**Re: Rapiscan AIT System Radiation Survey Reporting**

**Rapiscan Secure 1000**

**R-0646-1 Addendum  
(Documentation Errors)**

Product Name	Secure 1000SP (Single Pose)
Serial Number	S51037001
Radiation Emission Measurement	Radiation Survey Dated: 11/02/2010
RSO Initials

**2. Radiation Leakage Measurement: Survey Table. 2**

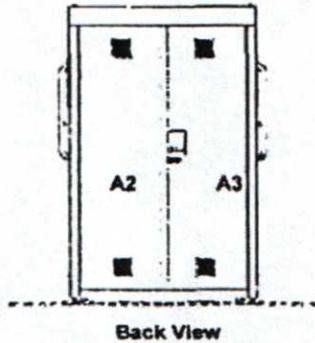
1. TABLE 2: Incorrect presentation of data in Column 3 for Measured Exposure. Indicated value is .1 uRem. The correct value should be 1 uRem.
2. TABLE 2: Incorrect presentation of data in Column 6 for Dose Equivalent. Indicated value is .18 uRem. The correct value should be 1.8 uRem.

The service technician should attend refresher training.

The corrected data indicates this system was operating within expected parameters. No re-survey is required for this system.
